Emergency Central Plant Upgrades
ADDENDUM #3
1/15/2018

1. Please see the attached revised limits of work for the Chiller:
2. Please see the attached responses to the RFIs.

Tri-City Medical Center
Emergency Central Plant Improvements (PR#17-0475)
OSHDP #S172470-37-00
Bid RFI Log

I-Beams needed above chiller; contractor provided and installed. Photo 1

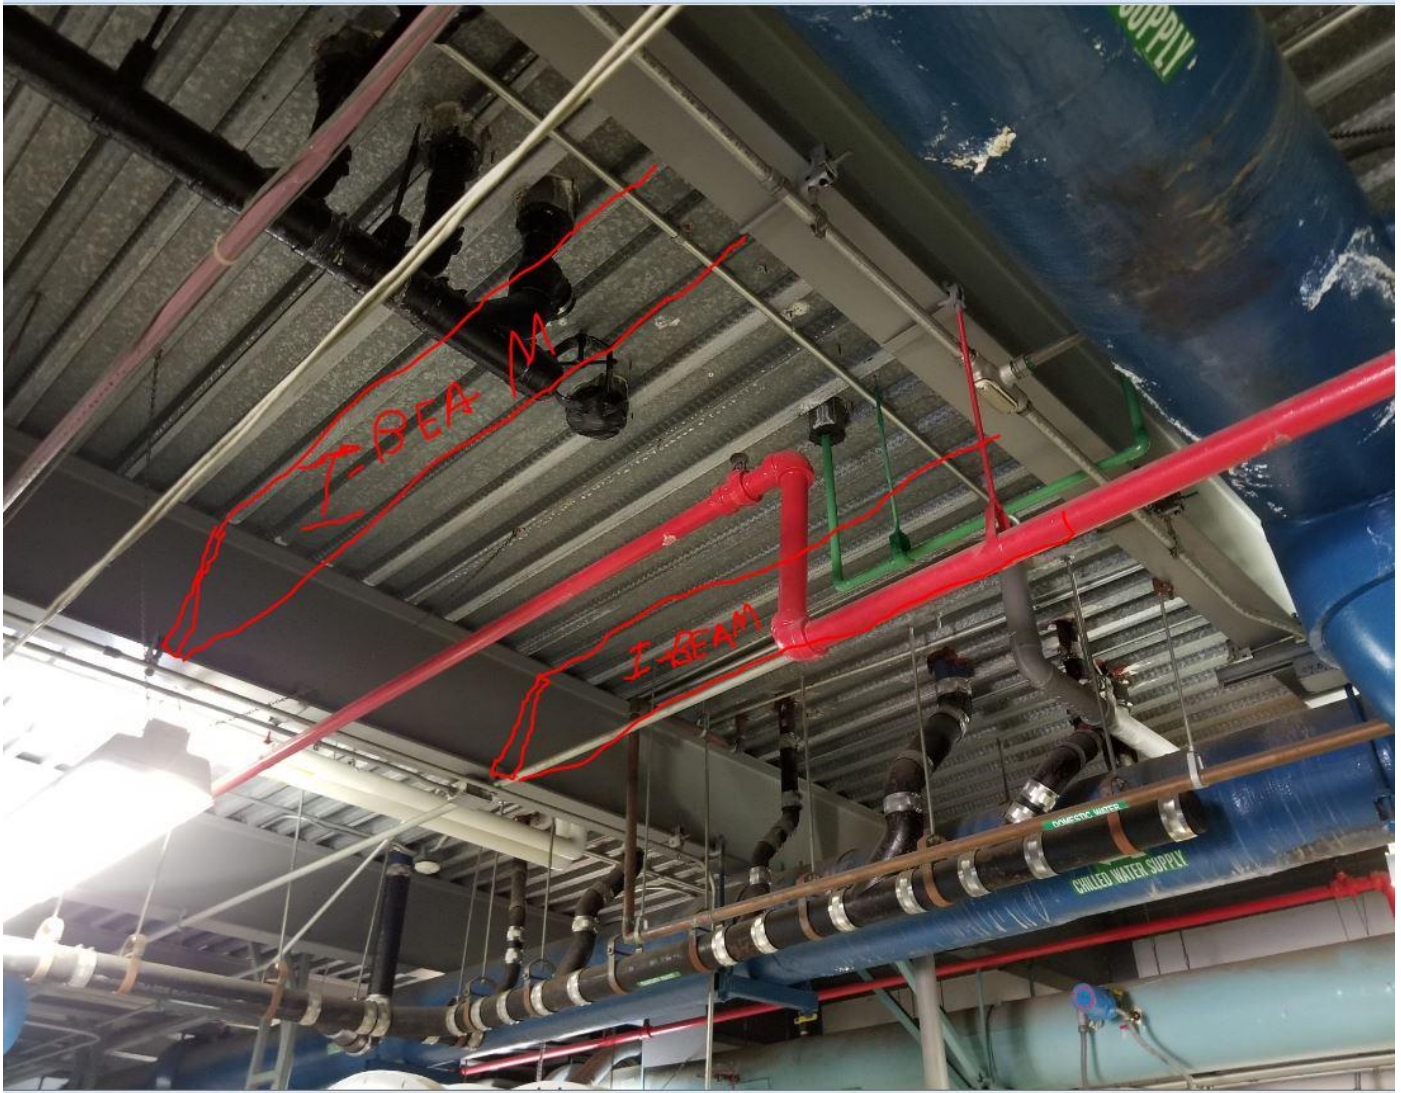
- **NOTE: Furnish & Weld (2) I-Beams above chiller for anchor point to secure rigging straps/chains for lifting compressor/motor back onto chiller. Pics of example I-Beam location below. I Beams to be certified for lifting 10,000 lbs. SEE NEXT 2 PAGES**
- **Receiving chiller, delivering to jobsite, removing from trailer and moving chiller through plant to final location**
- **Controls commissioning**
- **Hydronic & electrical install and interconnection**
- **Installation of remote mounted drive, including all wiring, conduit, communication wire**
- **Commissioning**
